UNITED STATES
NUCLEAR REGULATORY COMMISSION
WASHINGTON, D. C. 20555

BIG ROCK POINT PLANT

AMENDMENT TO FACILITY OPERATING LICENSE

Amendment No. 15
License No. DPR-6

1-2 ASSEMBLY Figure 5-8

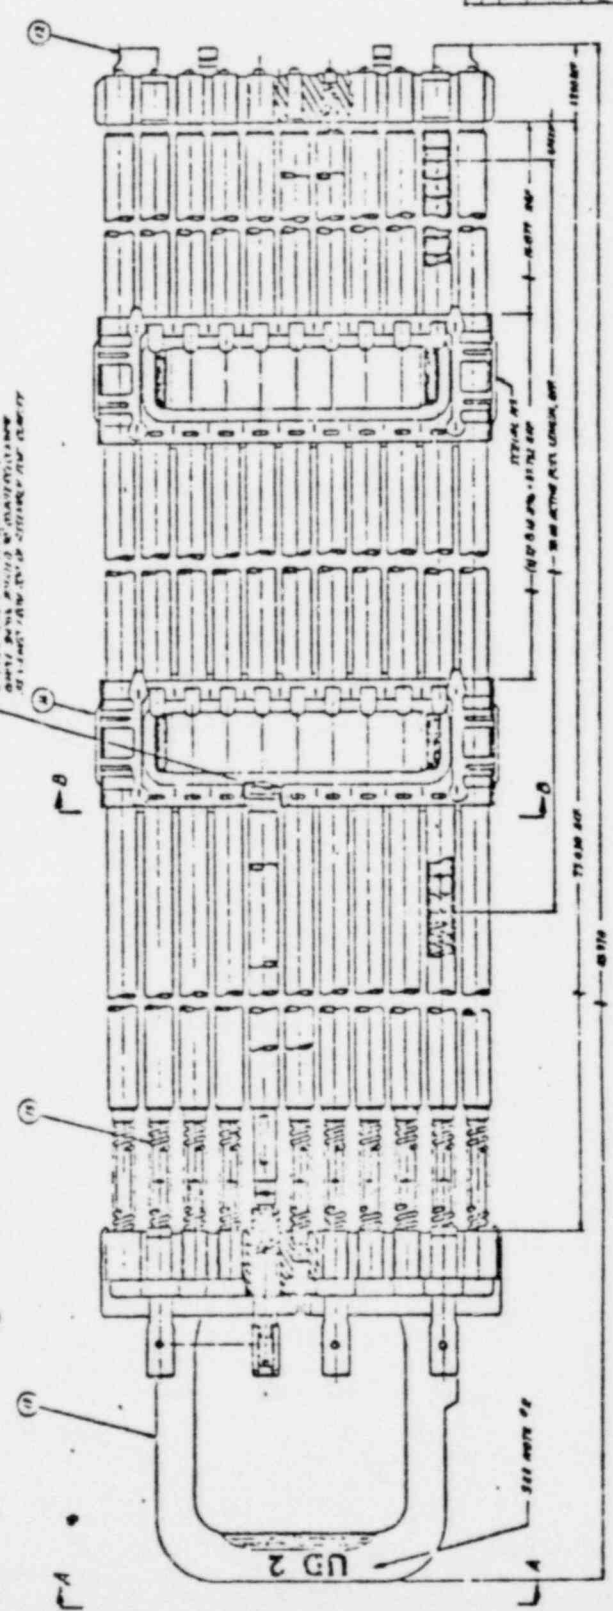
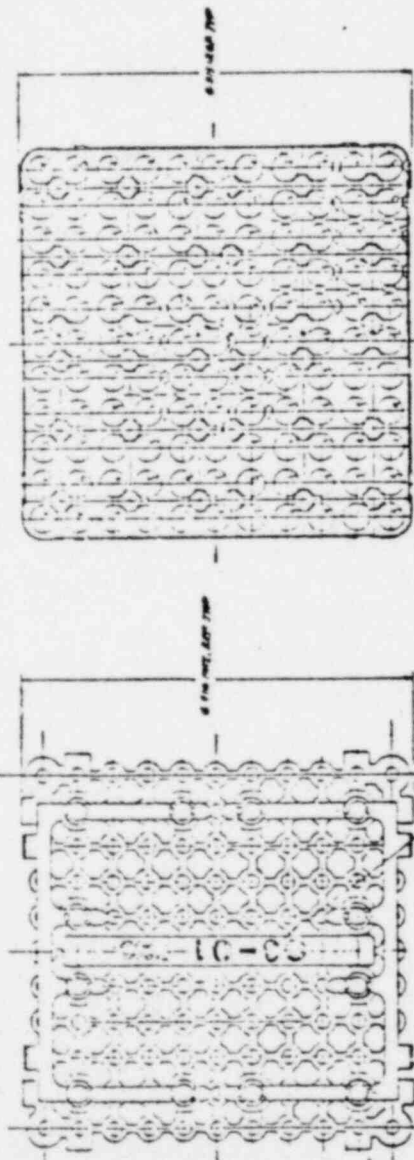
2. Add new Figure 5-8 attached.
3. Replace the following revised tables in Section 5.2.1(b):
Table 1 and Table 2
4. Add new Figure 1 and Figure 2 following Table 2.
5. Replace Table 8.2 with the revised Table 8.2.
6. Replace Section 11.3.1.4 with the following revised pages:
11-1 through 11-5
7. Delete Page 11-6 of Section 11.3.1.4.
8. In Paragraph 4.1.2(b) revise the first sentence to read: "A minimum of one reactor recirculating loop or its equivalent shall be used during all reactor power operations."
9. Replace pages 11-14 and 11-16 of Section 11.3.3.4 with attached revised pages.
